VEIC RESPONSES TO VSPC PARTICIPANT QUESTIONS

VEIC Responses to GMP's Questions

1/24/2011

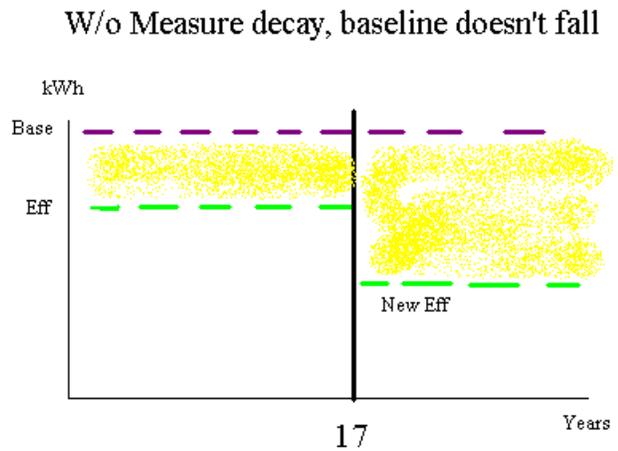
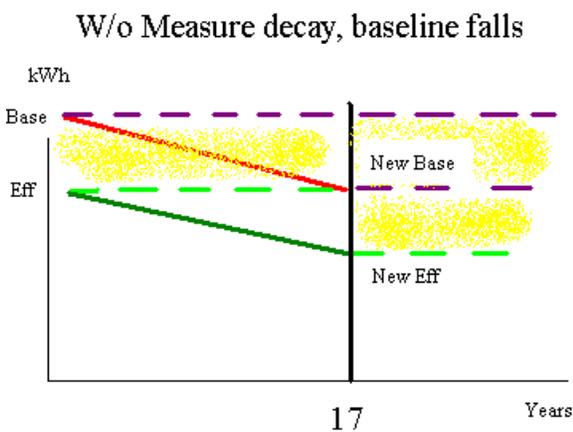
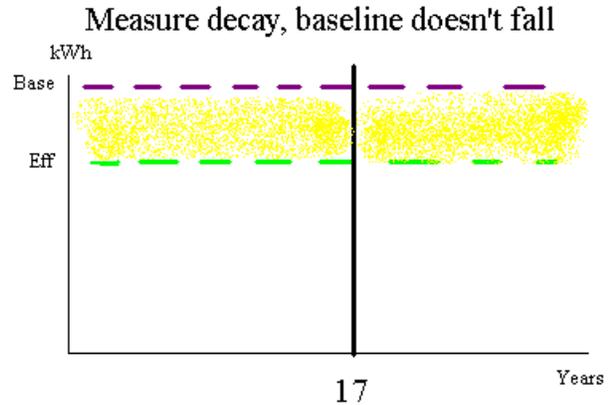
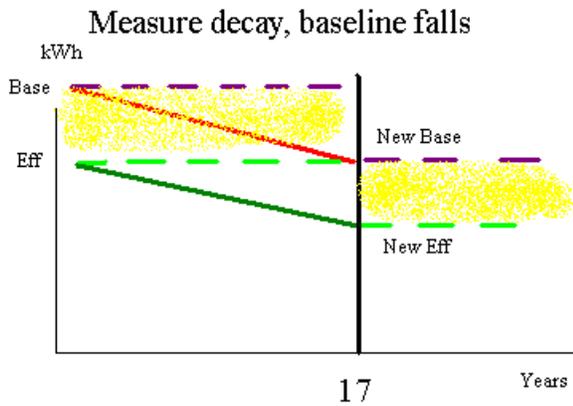
The data in the table below are from slides 26 and 27 of the VEIC presentation. Between 2020 and 2031, the residential “Cumulative Savings (w/decay)” increases by about 362,591 MWh and over the same period there were a total of 1,375,455 MWh in incremental efficiency savings added. This would suggest a significant amount of decay is happening in the second half of the forecast, and this is after the significant lighting standards adjustment. Aside from lighting programs (which have shorter lifetimes), should we really expect to see that much decay in the last ten years of the efficiency forecast?

Shouldn't we expect that the 3,600 kWh savings from a EWH fuel switch will not come back on the grid when the new water heater reaches the end of its life after 13 years? And for many other measures (refrigeration, window replacement, etc.), wouldn't you assume that most of the efficiency savings do not “reverse” back onto the grid either? If we allow the savings to decay, aren't we saying that the customer who participates in a refrigerator program will replace their refrigerator 17 years later with one that is at the baseline efficiency level from 17

years early if they are not given any incentives? Or would the customer install a refrigerator that is at least as efficient as the one they had, even without incentives?

Imagine the purchase of a refrigerator and the associated consumption in each scenario pictured below. If you have measure decay you end up saving (yellow) a constant amount over the years whether or not the baseline forecast predicts a fall in consumption. Without quantifying measure decay, you end up double counting savings. You count the savings from the first purchase (that don't decay), PLUS savings from the second after 17 years.

VEIC Response: Yes. In a maximum achievable forecast, one installs the maximum amount of cost-effective efficiency as early in the forecast period as possible. This results in the modeling of the retrofit of all refrigeration and other measures that have long and short measure lives in the first 10 years of the forecast period. As these measures reach the end of their effective useful lives, the savings decay. For example, VEIC models a suite of measures and increases their penetrations to 90% of the available market within the first 5 years of the analysis period, and then holds that penetration rate constant at 90% for the remaining period. If we assume that all measures have a measure life of 10 year, then, for the first ten years, each year you are adding 90% of the available new/replacement market savings. In the 11th year you add another 90% of the available market savings (for purchases that year), but the savings you added in year 1 are now over (measure decay). That is, those measures have come to the end of their life and their replacements are now part of the new 90% penetrations for the 11th year. The “new” savings would almost match the retired savings and so the cumulative savings would be pretty much constant from then on. There are a few measures that we don't model as having significant penetration until the later years, but for the majority of measures, we are ramping up penetrations pretty quickly.

VEIC Response: Savings or measure decay should be accounted for in the baseline forecast. The baseline forecast includes modeling of naturally occurring efficiency or efficiency that results from improved technology, codes and standards. That is, the baseline improvement in efficiency should capture or model the EWH fuel switch “not returning” to the grid.
